JUNE 1, 2023

On behalf of the Chemours Company FC, LLC and White Birch Group LLC I this letter is proposing a change to the soil Remediation Level (REL) for Operable Unit (OU) 3 presented in the Corrective Action Plan for On-Property Soils and Perched Water (CAP-OSP) Interim Action (IA) remedy for the Superlon Plastics Site (PERC/PIONEER 2017).

#### **Proposed Change to the CAP-OSP IA**

Operable Unit 3 Arsenic Soil Concentrations and  
Groundwater Concentrations in the Perched Aquifer  
Remedial Investigation Phase V  
Superlon Plastics Property, Tacoma, Washington

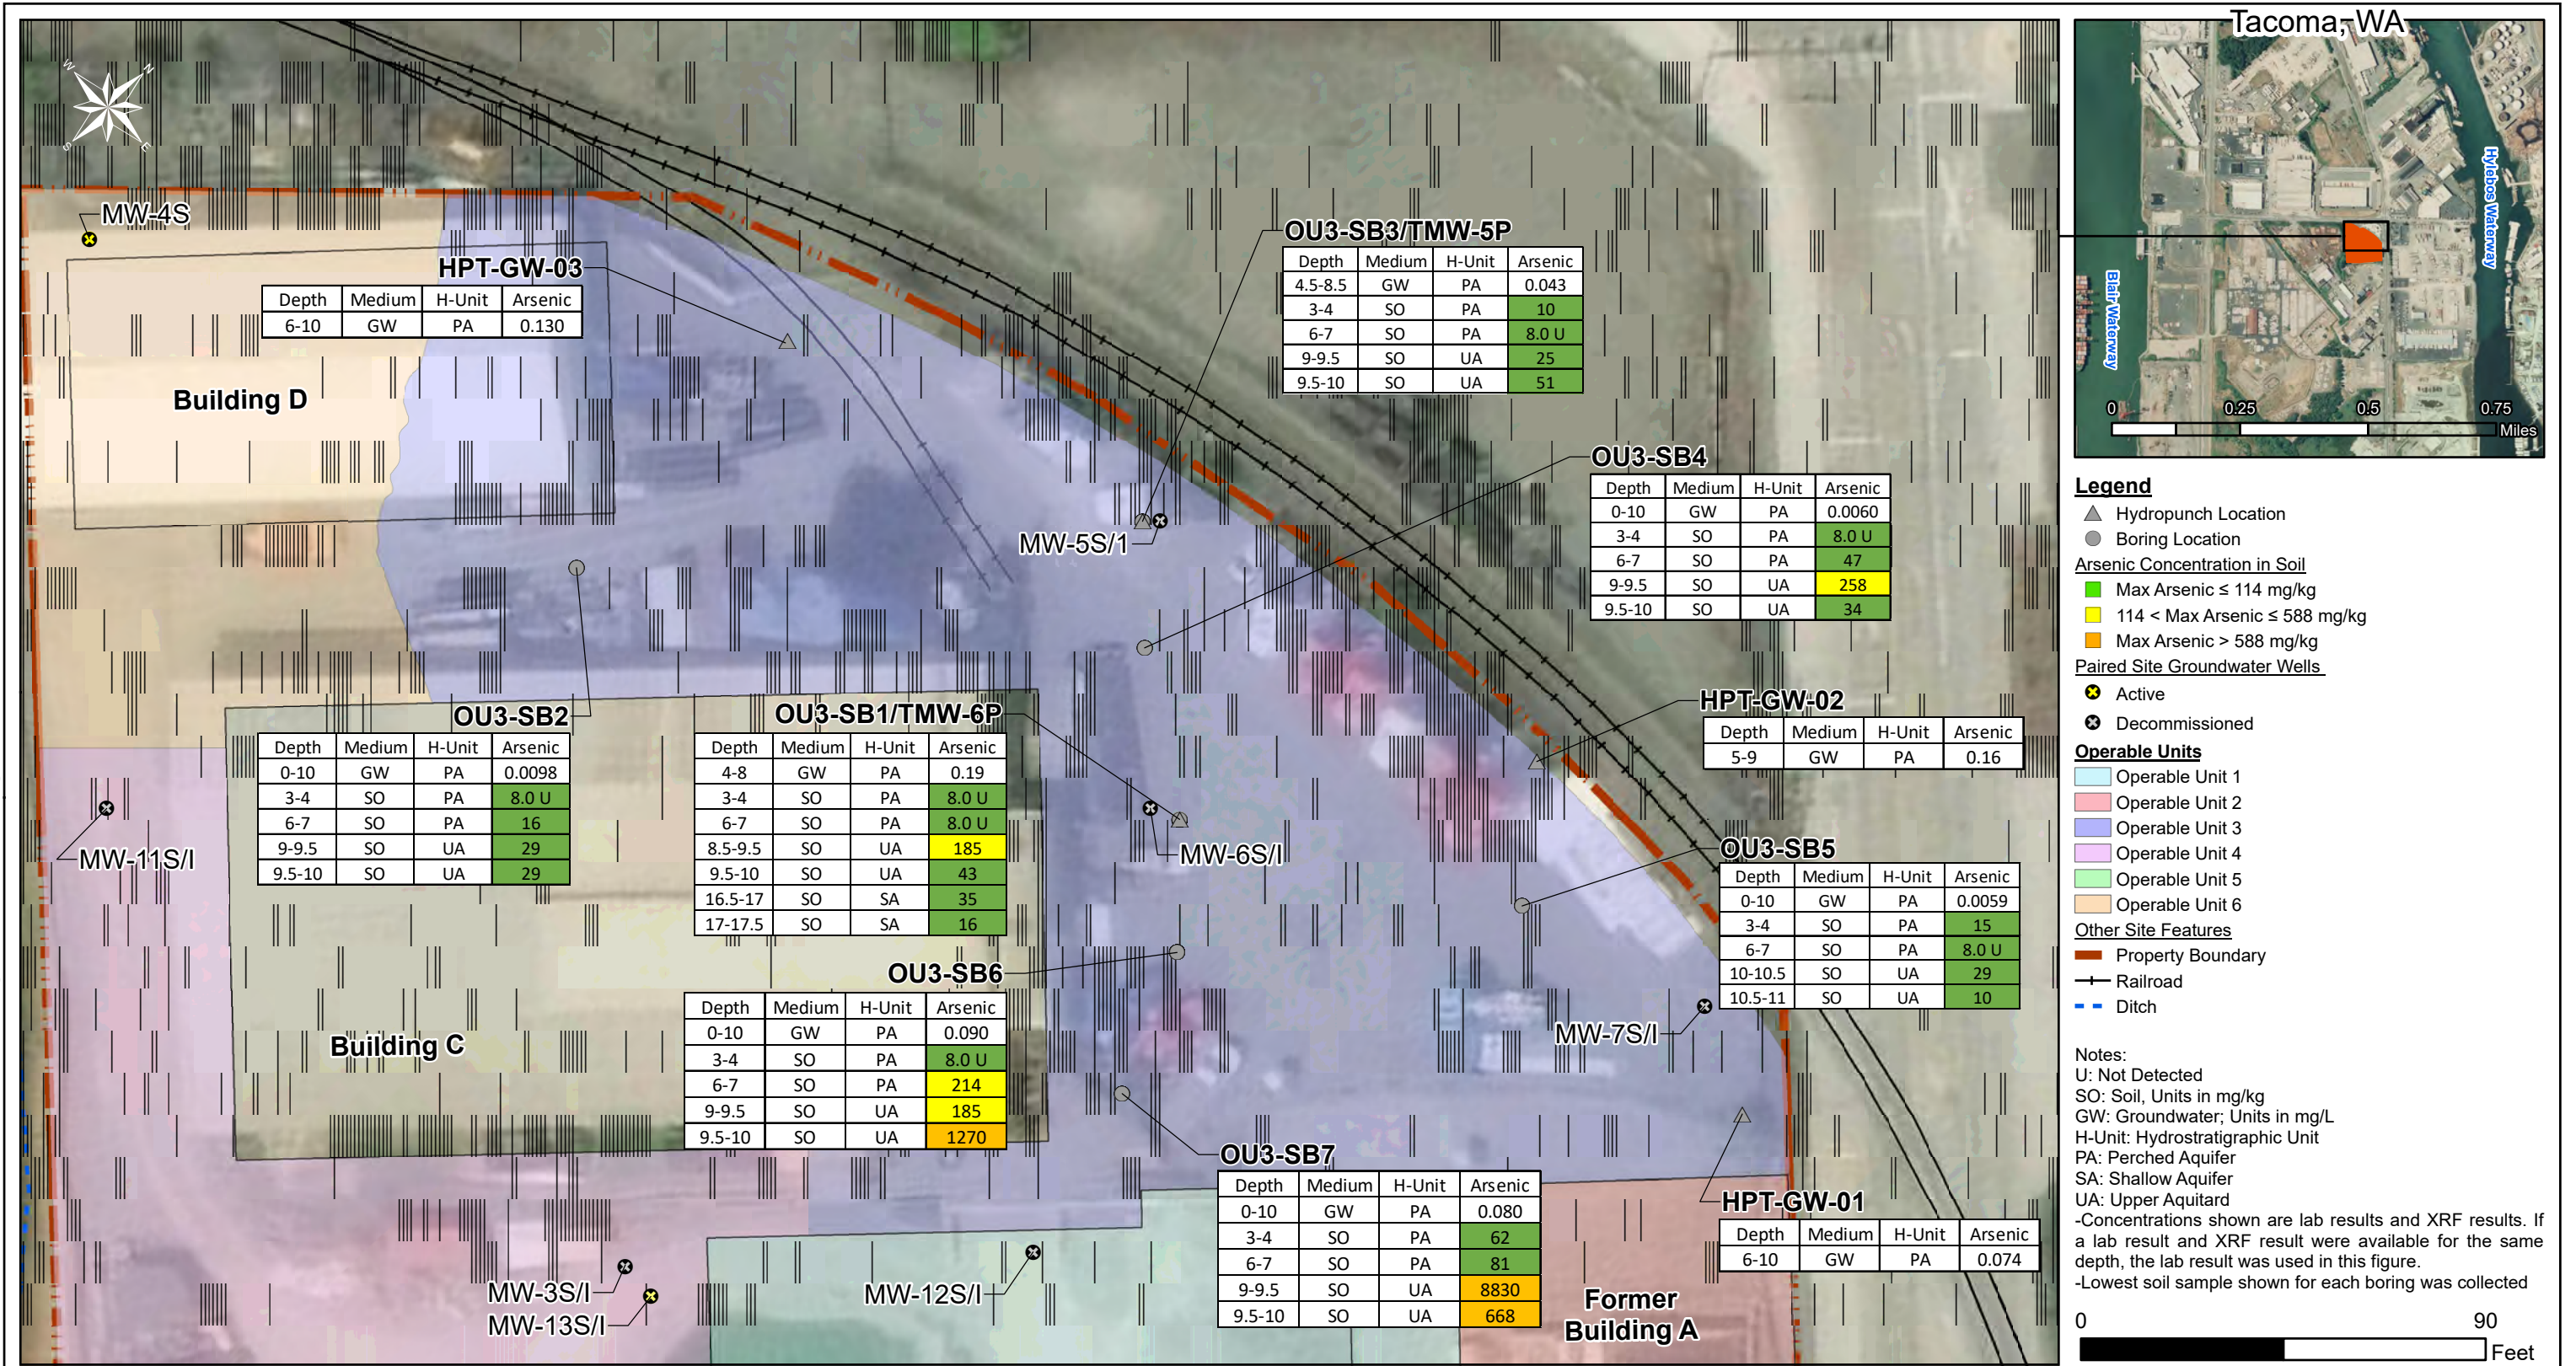
The CAP-OSP arsenic soil REL for each OU is the lower of the two soil exposure pathway CLs. The soil-to-perched water pathway calculated from leachability analysis was selected for OU 3 with an REL of 114 mg/kg. However, data from the Phase V RI indicates that some OU 3 arsenic soil concentrations exceed the leachability-based soil REL of 114 mg/mg, but collocated OU 3 arsenic groundwater concentrations do not exceed the Perched Water REL (0.67 mg/l) that the leachability-based soil REL was calculated from (see attached Figure 1). This indicates that arsenic within OU 3 is not leaching into groundwater as expected and the calculated soil-to-perched water pathway CL is overly conservative (see Phase V RI Section 4.6 for details). This conflict is likely due to the synthetic nature of the leaching analysis not representing real world phreatic zone chemistry conditions at OU 3 (i.e., if the leaching analysis represented the phreatic zone chemistry, higher concentrations of dissolved arsenic would be present in the Perched Aquifer within OU 3). Given that arsenic is not leaching into groundwater at concentrations that exceed the Perched Aquifer REL, the direct contact soil pathway REL is the applicable REL for OU 3.

It is proposed that the CAP-OSP arsenic soil REL for OU 3 be based on the direct contact soil pathway CL of 588 mg/kg.
